**ON-SITE SEWAGE DISPOSAL SYSTEM  
 HOWARD COUNTY HEALTH DEPARTMENT  
 BUREAU OF ENVIRONMENTAL HEALTH**

SUBDIVISION: Homewood Crossing LOT NUMBER: 8

ADDRESS: 11507 Fox River Drive PROPERTY OWNER: Toll MD III, LP

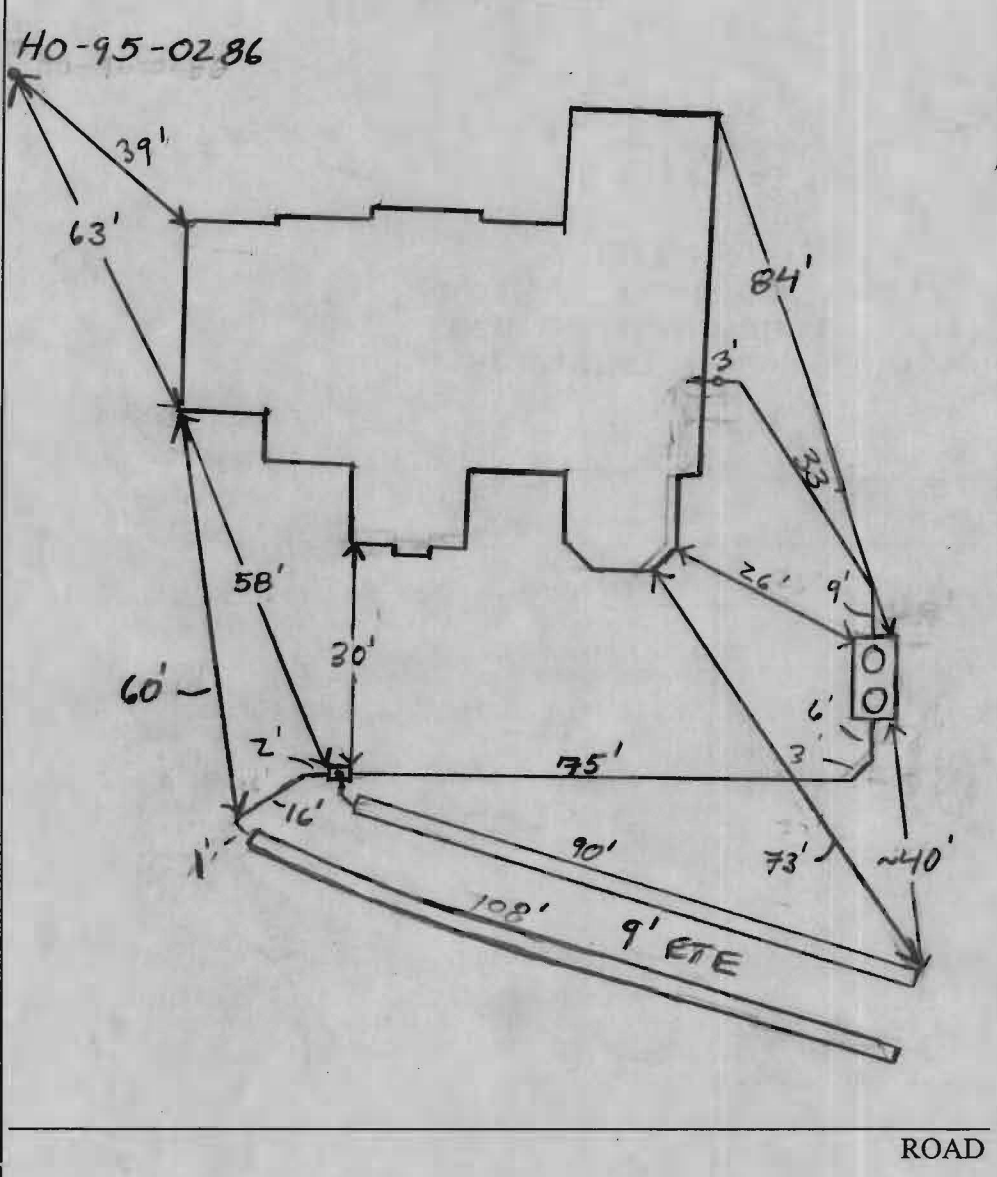
PRE-CONSTRUCTION 12/4/06 Layout. Run 2 trenches 1x90' and 1x108' (+) on contour. Attempted to layout per approved installation Septic Plan without file. house had moved in acceptedly located upper middle corner of SDA. Contour is a little off 25 shown on Septic plan (GAC) 12/5/06 Tanks and plumbing from house for tanks installed per plan. D box set and first trench started. (KW) 12/7/06 Second trench complete. 108' in length. slight curve start of trench; straight fill end. OK. to back fill (KW)
